# SERVICE BULLETIN

## MODIFIED EMPENNAGE BELLCRANK ASSEMBLY REIDENTIFICATION

MD900 helicopters, serial number 900-00008 thru 900-00106.  
All empennage bellcrank assemblies (P/N 900F2341712-101) in spares inventory.

**Figure 1. Empennage Bellcrank Assembly**

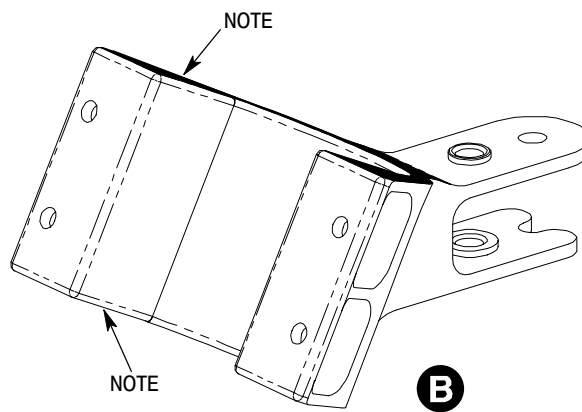
Some P/N 900F2341712-101 empennage bellcrank assemblies were modified by adding Karon coating to the upper and lower surfaces but were not reidentified with the new part number (900F6341712-101). The unmodified bellcrank is a life-limited part and the modified bellcrank has an unlimited life.

- (1). Inspect P/N 900F2341712-101 empennage bellcrank assembly for Karon (black) coating on upper and lower surfaces, as shown.
- (2). If bellcrank does not have Karon coating, no further action is required. Return part to spares inventory.
- (3). If bellcrank has Karon coating, perform C. Reidentification Instructions, Steps (1) through (3) below and return part to spares inventory.

- (b). If part number is 900F2341712-101, determine if it has Karon (black) coating on upper and lower surfaces, as shown.
  - 1). If bellcrank does not have Karon coating, no further action is required. Proceed to D. Completion Instructions below.
  - 2). If bellcrank has Karon coating, perform C. Reidentification Instructions below.

- (1). Line through existing part number (900F2341712-101); do not obscure serial number.

- (2). Permanent ink stamp or mark new part number (900F6341712-101) above lined through part number.
- (3). Cover area with moisture resistant varnish per manufacturer's instructions.

- (4). Update Installed Component Record and Component Historical Record sheet in helicopter log book by lining out the part number (900F2341712-101) and writing in the new part number (900F6341712-101) and that part number changed due to compliance with this Bulletin.
